Re: Petition No. 1587 – Endurant Energy petition for a declaratory ruling, pursuant to Connecticut General Statutes §4-176 and §16-50k, for the proposed construction, maintenance and operation of a 4.9-megawatt AC battery energy storage facility located at 350 Knotter Drive, Cheshire, Connecticut, and associated electrical interconnection

Enclosed for filing with the Connecticut Siting Council (“Council”) are Endurant Energy’s responses to the Connecticut Siting Council’s September 26, 2023 interrogatories.

PROJECT:  
**BATTERY ENERGY STORAGE  
ACCEL - CHESHIRE  
(4.9MW / 9.8MWH)**

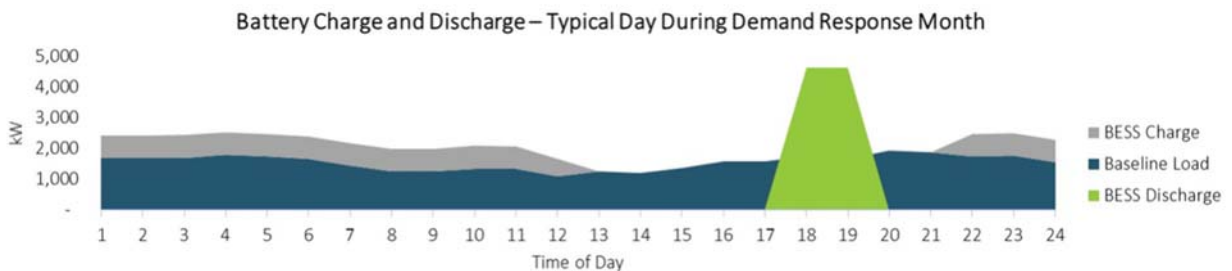
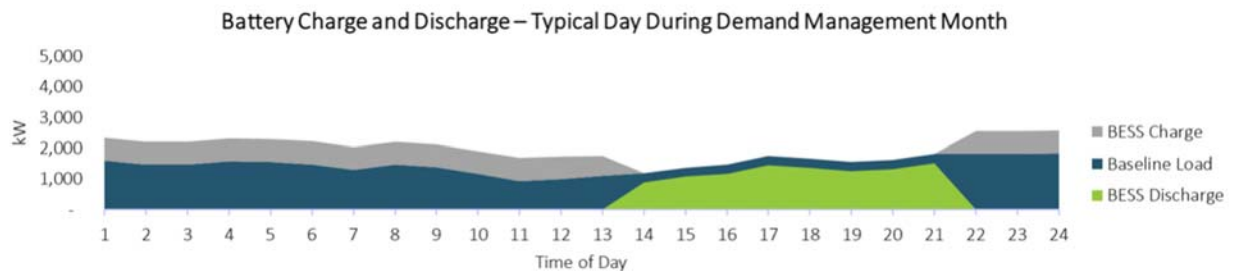
Q-CSC 10: What is the approximate percentage of Accel's annual electric load that would be served by the BESF?

A-CSC 10: Because this is an energy storage system and not an energy generation system, when the BESF serves Accel's building, it will not 'off-set' a specific portion of Accel's overall load, but instead will 'shift' the load required to lower-priced 'off-peak' times from expensive peak times (when the battery will be discharged). This load shifting, or management, will occur year-round. See the Demand Management graph below. During the summer months, from June 1 through September 31, the battery will be participating in the ESS program. Again, it will charge during off-peak hours, but during the program's Performance Season, it will discharge as requested by the Program Administrators. See the Demand Response graph below.

In terms of approximate percentages, the total annual consumption of the site with the battery is expected to be around 3,500 MWh, and the load that the battery will manage will be 800 MWh - approximately 23% served.

**Accel - Cheshire  
350 Knotter Road  
Parcel and Site Boundaries**

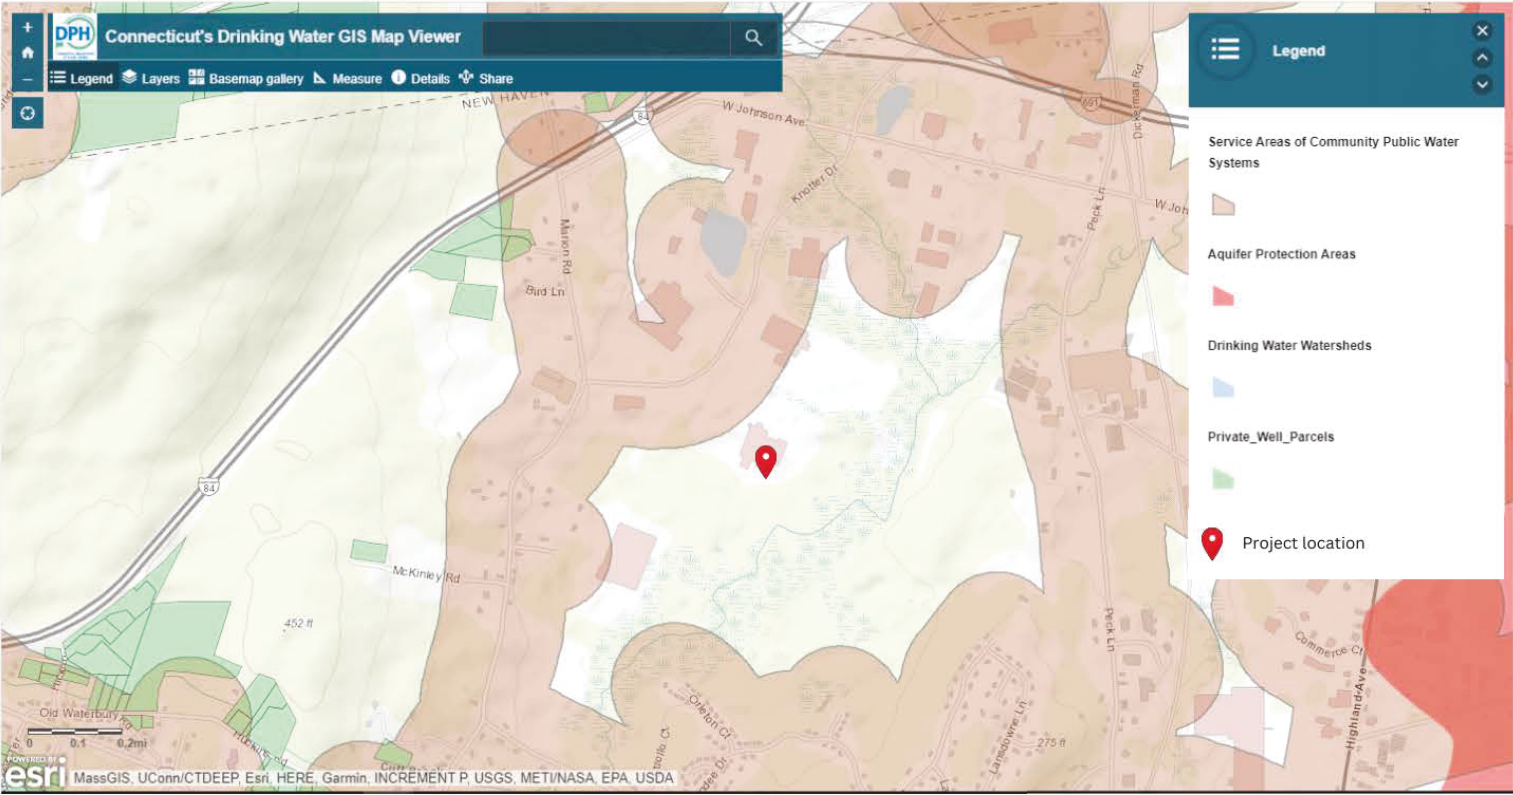
- Q-CSC 6: Submit a map clearly depicting the boundaries of the battery energy storage facility (BESF) site and the boundaries of the host parcel(s). Under Regulations of Connecticut State Agencies (RCSA) §16-50j-2a(29), **“Site”** means a contiguous parcel of property with specified boundaries, including, but not limited to, the leased area, right-of-way, access and easements on which a facility and associated equipment is located, shall be located or is proposed to be located.
- A-CSC 6: The BESF site and host parcel are mapped on Attachment CSC-6-1. The "Site" is defined as the area of the host parcel that is to be leased by Endurant and is identified by the BESF perimeter fencing. No rights-of-way, access or easements are associated with the proposed Site. The final dimensions may vary slightly from what is shown depending on utility requirements.

Interrogatory #43  
Aquifer and Well Mapping

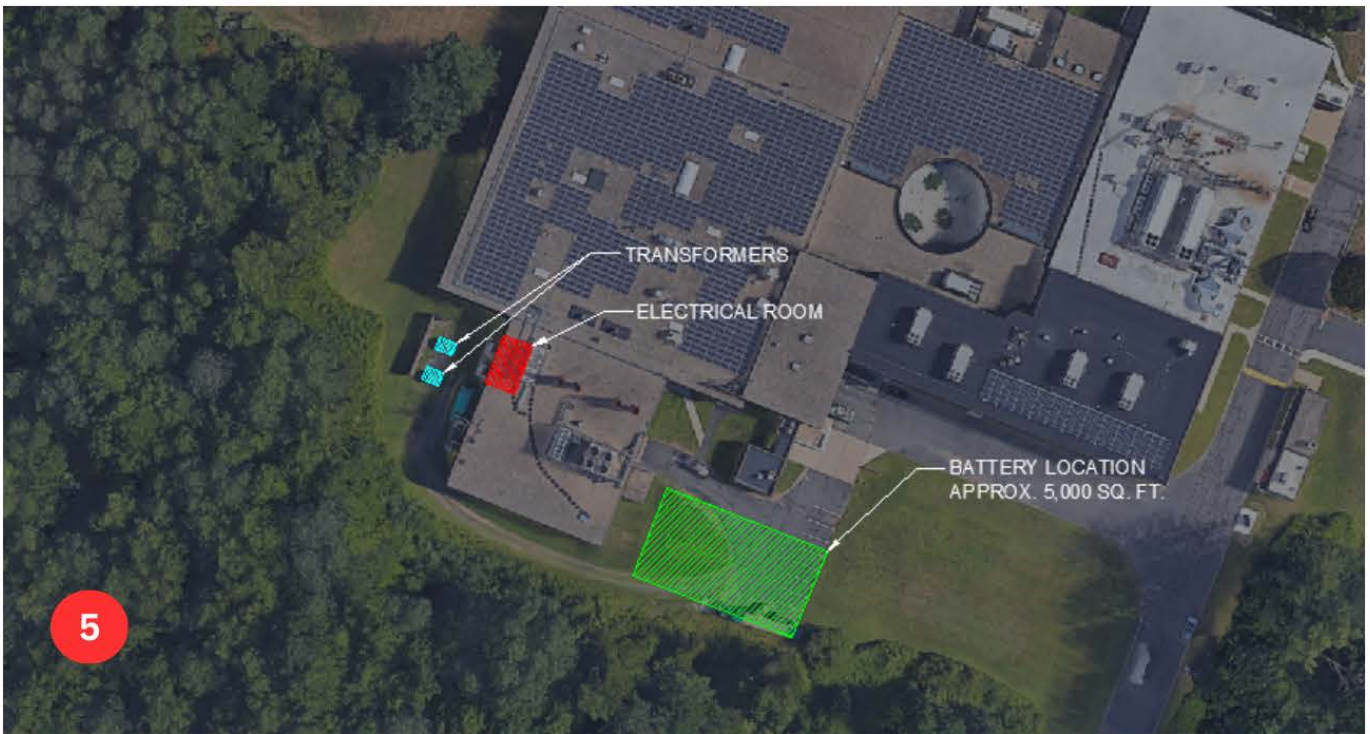
Q-CSC 43: Are there any wells on the site or in the vicinity of the site? If so, how would Endurant protect the wells and/or water quality from potential construction, operation and/or emergency response impacts?

A-CSC 43: There are no wells on the site. The closest well parcel is located approximately 4,200 feet from the project site. The closest aquifer protection area is approximately 6,700 feet from the project site, and well out of the influence of construction, operation and/or emergency response impacts. See Attachment CSC-43-1.
